UNITED STATES PATENT AND TRADEMARK OFFICE

APPLICATION NO.	FILING DATE	FIRST NAMED INVENTOR	ATTORNEY DOCKET NO.	CONFIRMATION NO.
09/931,252	08/17/2001	Takashi Yano	520.40478X00	1490

Office Action Summary

DETAILED ACTION

Fig. 5

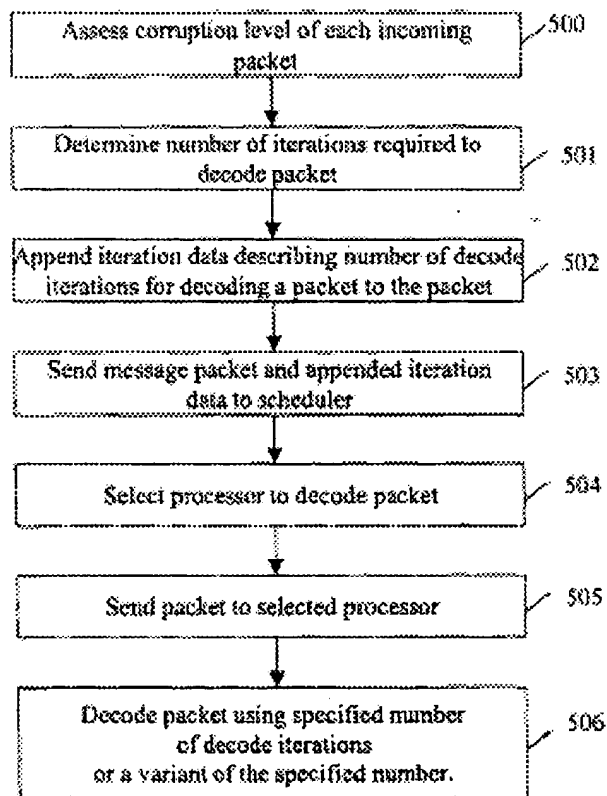
As per claim 1, **FREEMAN** substantially teaches, in Fig. 5 and related description, turbo decoder means for application of input turbo-encoded data; of repeatedly carrying out turbo

decoding a number of times to restore the originally transmitted data; of judging the reliability of the soft outputted decoded result from statistics of the soft output result; of calculating the root mean square (a statistical measure) of the soft output and comparing (or judging) the result; of controlling the number of iterations to run based on the judgment result; of repeating the turbo decoding in accordance with the comparison result of the root mean square. Hence FREEMAN teaches of controlling the number of iterations (repetitions) based on the judgment result.

As per claims 5 and 6, FREEMAN and Schurgers et al. substantially teach of a turbo decoder that decodes turbo encoded data in Fig. 5 of judging the reliability of the soft outputted decoded result from statistics of the soft output result and of controlling the number of iterations to run based on the judgment result.

Figure 8: Performance with an acceptable BER of 10^{-3} for rate $\frac{1}{2}$ turbo code, $K=512$, 4 states, fading channel

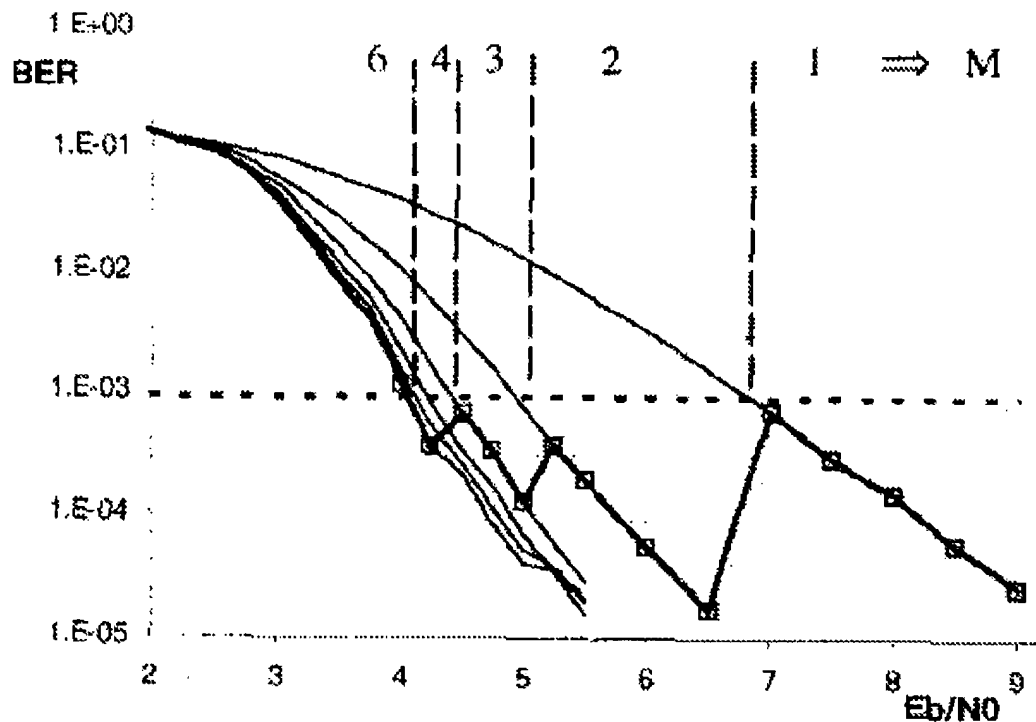
However **Schurgers et al.**, in an analogous art, discloses such soft coding iteration termination algorithms in "*Adaptive turbo decoding for indoor wireless communication*," e.g., **Schurgers et al.** discloses an "*Adaptive turbo decoding*," e.g., in Fig. 8 and Tables 1-2, performing an equivalent functionality for turbo decoding based on channel information and characteristics. Fig. 1 shows plural wireless stations forming a communications networks, which stations transceive data under different channel attenuation characteristics, e.g., bit error rate, or various signal-to-noise ratios or various signal-to-interference ratios, such as, ratio of pilot channel transmission signal to pilot channel reception signal, as depicted by Fig. 2.

Sections 4-5 and Fig. 8 render obvious the claimed invention whereby a decoding algorithm transforms the fixed number of iterations of a conventional turbo code into an adaptive iterative process by incorporation of termination criteria, e.g., based on channel fading parameters. Based on a ratio of transmitted signal power or energy, viz., E_B to channel additive white Gaussian noise power N_0 on page 110: col. 2 last sentence and Table 2.

Briefly, when the signal to noise ratio is large, a reflection of good channel characteristics, the number of decoding iterations is accordingly reduced. When the signal to noise ratio is low, i.e., below a preset threshold, indicative of poor channel characteristics, the

number of decoding iterations is increased. Dynamically adapting the iterative process considerably reduces transmission-decoding power consumption when signal attenuation is negligibly low under good channel conditions as described in Section 6 of page 111.
